## **RESOLUTION AGREEMENT**

University of Central Missouri  
OCR Docket Number 07162005

**Compliance Chart**  
University of Central Missouri, Warrensburg, Missouri  
OCR Docket #071620005

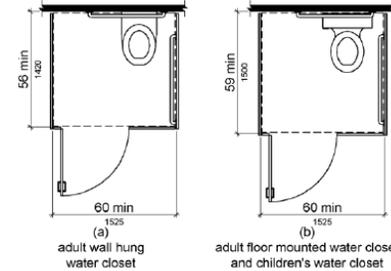
<p><b>#137</b></p> <p><b>Entrance Door</b></p>	<p><u>4.13.6: Maneuvering clearances at doors:</u> Minimum maneuvering clearances at doors that are not automatic or power-assisted shall be as shown in Fig. 25 with a level and clear floor area within the required clearances.</p> <p><u>4.13.11: Door opening force:</u> The maximum force for pushing or pulling open a door shall be 5 pounds for an interior hinged door.</p>	<p>There is not a minimum of 18" of maneuvering clearance beyond the latch side of the door.</p> <p>The force to open the restroom entrance door is 10 pounds, but the maximum force allowed is 5 pounds.</p>	 <p>Entrance to male restroom #137.</p>	<p>Reconfigure the wall to ensure there is a minimum of 18" of maneuvering clearance beyond the latch side of the door or add an automatic door opener. 404.2.4</p> <p>Ensure door opening force is 5 pounds maximum. 404.2.9(1).</p>

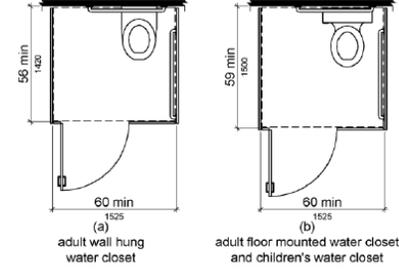
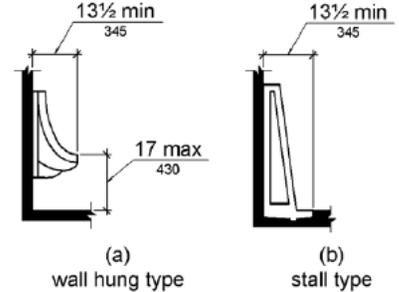
<p>#133</p> <p><b>Toilet Stall</b></p>	<p><u>4.17.3: Size &amp; arrangement:</u> The size and arrangement of the standard toilet stall shall comply with Fig. 30(a) (Standard Stall). The centerline of the toilet shall be 18” from a wall or partition.</p> <p><u>4.16.3: Water closet (toilet) height:</u> The water closet height shall be 17” to 19” measured to the top of the toilet seat.</p> <p><u>4.16.5: Flush controls:</u> Controls for flush valves shall be mounted on the wide side of toilet areas no more than 44” above the floor.</p>	<p>The centerline of the water closet is 17”, which does not comply with the 1991 Standards (centerline must be 18” from the side wall or partition), but complies with the 2010 Standards (centerline 16” min. and 18” max.).</p> <p>The height of the toilet is 15.75” (it should be 17” to 19”).</p> <p>The flush control for the toilet is not located on the open side of the toilet.</p> <p>The wall-mounted metal basket above the side grab bar may interfere with the use of the side grab bar.</p>	 <p>The toilet flush control is not located on the open side of the toilet. The wall-mounted metal basket above the side grab bar in the toilet stall may interfere with maneuvering and the use of the grab bar.</p>	<p>Adjust the toilet height to no less than 17” and no greater than 19” above the floor measured to the top of the seat, or replace the toilet. 604.4.</p> <p>Reconfigure the toilet so that the flush control is on the open side of the water closet. 604.6.</p> <p>Remove the wall-mounted metal basket above the side grab bar. 609.3.</p>

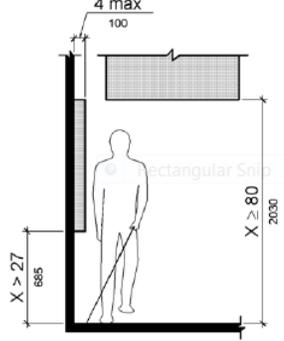
<p><b>#069</b> <b>Urinals</b></p>	<p><b>4.18.2: Urinals: Flush Controls:</b> The flush controls for urinals shall be hand operated or automatic, and shall comply with 4.27.4, and shall be mounted no more than 44” above the floor.</p>	<p>The urinal flush controls are 49” from the floor, but should be mounted no more than 44” above the floor, based on the 1991 Standards.</p>	 <p>Stall-type urinals in #069.</p>	<p>Ensure the urinal flush control is mounted 48” maximum above the floor (where reach depth is 20” maximum) or 44” maximum above the floor (where reach depth is 20-25” maximum). 605.4 and 308.2.2. See Fig. 605.2(b), below.</p>  <p>Figure 605.2 Height and Depth of Urinals</p>
<p><b>#069</b> <b>Protrusions</b></p>	<p><b>4.4.1: Protrusions:</b> Wall-mounted objects with leading edges between 27” and 80” above the floor shall protrude no more than 4” into walks, halls, corridors, passageways, or aisles.</p>	<p>The towel dispenser near the sink is mounted between 27” and 80” above the floor and protrudes 8” from the wall.</p>		<p>Provide a fixed barrier detectable by canes under the towel dispenser or provide OCR with another plan to reconfigure or eliminate the protrusion. 307.2. See Fig. 307.2, below.</p>

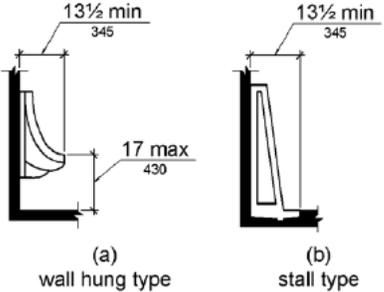
<p><b>#2210</b></p> <p><b>Signage</b></p>	<p><u>4.1.3(16)(a) &amp; (b): Signs (scope):</u> Signs which designate permanent rooms and spaces shall comply with 4.30.1, 4.30.4, 4.30.5 and 4.30.6. Signs which provide information about functional spaces shall comply with 4.30.1, 4.30.2, 4.30.3, and 4.30.5.</p> <p><u>4.30.6: Signs: Mounting Location and Height:</u> Where permanent identification is provided for rooms and spaces, signs shall be installed on the wall adjacent to the latch side of the door. Mounting height shall be 60" above</p>	<p>The sign with tactile information and the symbol of accessibility is mounted on the restroom door (pull side) instead of the latch side adjacent to the door and is mounted too high (67" high near the centerline).</p> <p>A person standing within 3" of the sign would be within the swing of the door.</p>	 <p style="text-align: center;">Tactile sign mounted on female restroom entrance door.</p>	<p>Mount the tactile sign with the symbol of accessibility on the wall adjacent to the latch side of the restroom entrance door in compliance with 703.4.1 and 703.4.2. See Fig. 703.4.1 (Sign height) and Fig. 703.4.2 (Sign location), below.</p>  <p style="text-align: center;">Figure 703.4.1 Height of Tactile Characters Above Finish Floor or Ground</p>

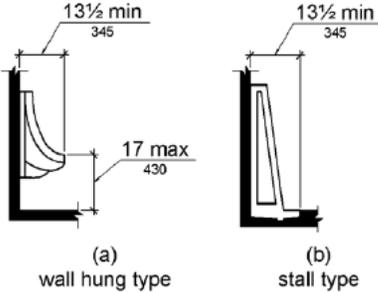
#2230 <b>Toilet Stall</b>	4.17.3: <u>Size &amp; arrangement:</u> The size and arrangement of the standard toilet stall shall comply with Fig. 30(a) (Standard Stall). The centerline of the toilet shall be 18” from a wall or partition.  4.16.5: <u>Flush controls:</u> Flush controls shall be hand operated or automatic and shall comply with 4.27.4. Controls for flush valves shall be mounted on the wide side of toilet areas no more than 44” above the floor.  4.16.3: <u>Water closet (toilet) height:</u> The water closet height shall be 17” to 19” measured to the top of the toilet seat.  4.17.6: <u>Grab bars:</u> Grab bars shall comply with 4.26 and the length and positioning shall comply with Fig. 30(a)-(d).	The height of the toilet is 15” (it should be 17” to 19”).  The flush control for the toilet is not located on the open side of the toilet.  The side grab bar does not extend at least 52” from the rear wall (it only extends 48.5”).	 <p>The toilet flush control is not located on the open side of the toilet.</p>	Adjust the toilet height to no less than 17” and no greater than 19” above the floor measured to the top of the seat, or replace the toilet. 604.4.  Reconfigure the toilet so that the flush control is on the open side of the water closet. 604.6.  Replace the side grab bar with a grab bar that complies with 604.5 and 609. See Figures 604.5.1 and 604.5.2, below.   <p><b>Figure 604.5.1 Side Wall Grab Bar at Water Closets</b></p>

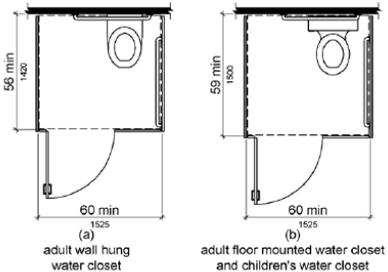
#4270 <b>Entrance Door</b>	4.13.6: <u>Maneuvering clearances at doors:</u> Minimum maneuvering clearances at doors that are not automatic or power-assisted shall be as shown in Fig. 25 with a level and clear floor area within the required clearances.	There is not a minimum of 18" of maneuvering clearance beyond the latch side of the door.  The force to open the restroom entrance door is 10 pounds, but the maximum force allowed is 5 pounds.	[See photo, above, for entrance door to male restroom]	Reconfigure the wall to ensure there is a minimum of 18" of maneuvering clearance beyond the latch side of the door or add an automatic door opener. 404.2.4 (including 4.2.4.3 for recessed door, unless 8" or less projection).  Ensure door opening force is 5 pounds maximum. 404.2.9(1).

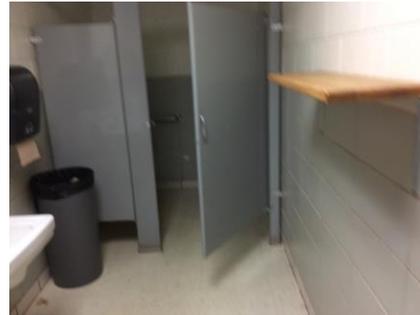
<p><b>Designated accessible male restroom # 103</b></p> <p><b>First floor of Utt Building</b></p>	<p><u>Applicable accessibility standards:</u> 1991 Standards</p> <p><u>Alterations:</u> This restroom was altered 1-2 years after the University's 1992 ADA Survey and Transition Plan, according to information provided by the University.</p>		 <p>Designated accessible male restroom #103.</p>	
<p><b>#103 Sinks</b></p>	<p><u>4.19.4: Exposed Pipes:</u> Hot water and drain pipes under sinks shall be insulated or otherwise configured to protect against contact.</p>	<p>The pipe below the designated accessible sink is not insulated or otherwise configured to protect against contact.</p>	 <p>Designated accessible sink with exposed pipe.</p>	<p>Insulate the pipes under the accessible and children's sinks or otherwise configure to protect against contact. 606.5</p>
<p><b>#103 Toilet Stall</b></p>	<p><u>4.17.3 &amp; 4.22.4: Size &amp; arrangement:</u> The size and arrangement of the standard toilet stall shall comply with Fig. 30(a) (Standard Stall). The toilet stall width shall be 60" min. and the depth shall be 56" min. for a wall mounted toilet, or 59" depth for a floor-mounted toilet. The centerline of the toilet shall be 18" from a wall or partition.</p> <p><u>4.16.5: Flush controls:</u> Flush controls shall be hand operated or automatic and shall comply with 4.27.4. Controls for flush valves shall be mounted on the wide side of toilet areas no more than 44" above the floor.</p>	<p>The toilet stall dimensions are 67.5" wide and 57" deep (59" minimum depth is required with a floor-mounted toilet).</p> <p>The centerline of the water closet is 14", which does not comply with the 1991 Standards (centerline must be 18" from the side wall or partition), and it does not comply with the 2010 Standards (centerline 16" min. and 18" max.).</p> <p>The flush control for the toilet is not located on the open side of the toilet.</p> <p>The side grab bar is 36" long and extends 39" from the rear wall. The rear grab bar is 30.5" long</p>	 <p>The toilet flush control is not located on the open side of the toilet.</p>	<p>Alter the toilet stall (for proper clearance) and the dispenser to comply with 604, including proper dimensions and arrangement (see Fig. 604.8.1.1, below).</p>  <p style="text-align: center;"><b>Figure 604.8.1.1</b> <b>Size of Wheelchair Accessible Toilet Compartment</b></p> <p>Move or replace the toilet so that the centerline of the toilet is 16"</p>

The side and rear continuous grab bar is mounted 1.75" between the wall and the grab bar, instead of 1.5".  
 The coat hook is mounted 63" above the floor.

Reconfigure the toilet so that the flush control is on the open side of the water closet. 604.6.

Replace the continuous grab bar with a grab bar(s) that complies with 604.5 and 609 (including mounting grab bar with 1.5" of space between the wall and the grab bar). See Figures 604.5.1 and 604.5.2, below.

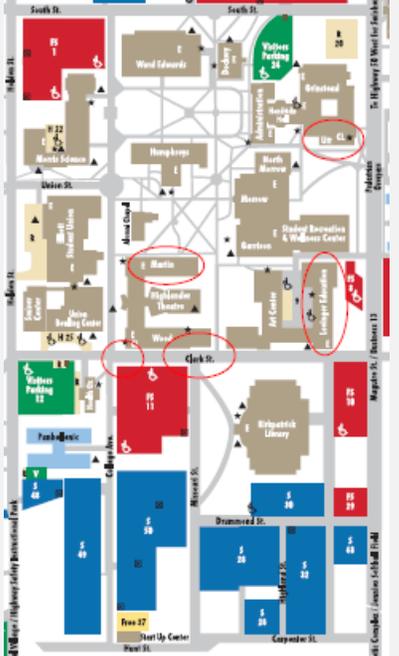
<p><b>#103</b></p> <p><b>Protrusions</b></p>	<p><u>4.4.1: Protrusions:</u> Wall-mounted objects with leading edges between 27" and 80" above the floor shall protrude no more than 4" into walks, halls, corridors, passageways, or aisles.</p>	<p>The towel dispenser near the sink and the shelf are mounted between 27" and 80" above the floor and protrude more than 4" from the wall.</p>	 <p>The towel dispenser is on the left and the shelf is on the right in this picture.</p>	<p>Provide a fixed barrier detectable by canes under the towel dispenser and remove the shelf, or provide OCR with another plan to reconfigure or eliminate the protrusions. 307.2. See Fig. 307.2, below.</p>  <p><b>Figure 307.2</b> <b>Limits of Protruding Objects</b></p>

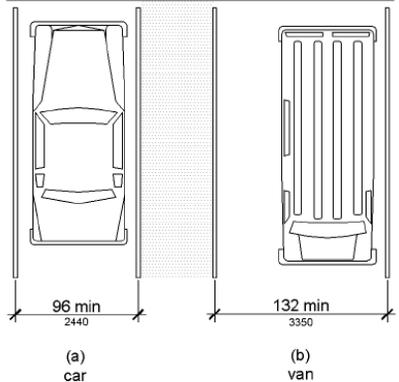
<b>Signage for inaccessible restrooms in the Utt Building</b>	<u>4.1.3(16): Building Signage:</u> Other signs which provide direction to or information about functional spaces of the building shall comply with 4.30.1, 4.30.2, 4.30.3, and 4.30.5 (temporary signs are exempted).	For any restroom on each level of the Utt Building that is not accessible, a directional sign to the accessible restroom(s) on that level should be installed.	[No photo]	Ensure directional signs are installed at inaccessible restrooms in the Utt Building and that they comply with 216.8, 703.5, and 703.7.2.1.
